From: Brendan Metcalfe <[REDACTED]>
Sent: Wednesday, 2 December 2020 7:30 AM
To: Jane Anderson - IPCN <[REDACTED]>
Cc: Renee Coull <[REDACTED]>; Eva Stanbury <[REDACTED]>
Subject: FW: 30-46 Auburn Road Regents Park - IPC - Question on Notice

I refer to the IPC briefing yesterday for 30-46 Auburn Road Regents Park. At the briefing we took a question on notice in relation to building heights and the provision of roof top open space. Please see our response below.

FIGURE 1: BUILDING HEIGHTS

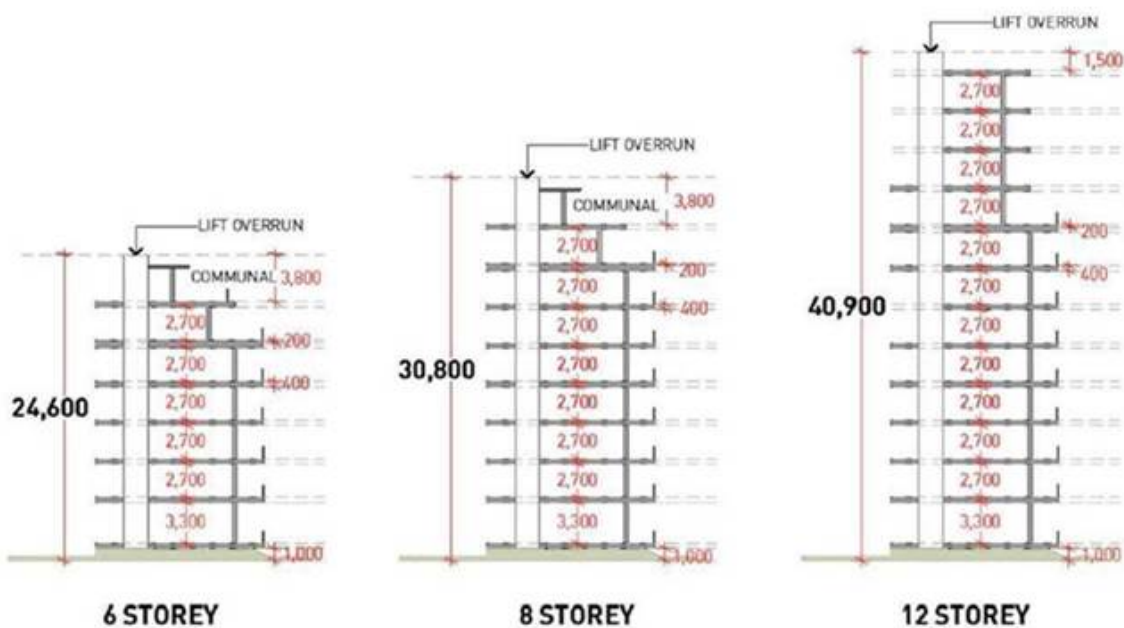
- The Smith & Tzannes independent peer review, prepared on behalf of the proponent, dated 26 August 2020, presented alternate heights for the proposal, including a 41m height for the 12 storey building. This varies from the proponents original request for 47m for the 12 storey building. The peer review indicates 3.8m is required for lift overruns to rooftop communal open space on the 6 and 8 storey buildings, but concludes that the 47m height is excessive for the 12 storey building and that it is not desirable to have communal open space at that level due to potential wind speeds that would reduce the amenity of this space. Refer to the figure below.

- The Department recommended heights are based on the Apartment Design Guideline (ADG) metrics to ensure the number of storeys can be delivered. The Department considers that supporting the height in metres proposed by the proponent, is inconsistent with the ADG and could allow for additional storeys being accommodated on the site above what has been supported through this planning proposal. The 41m control is not intended to facilitate rooftop open space.
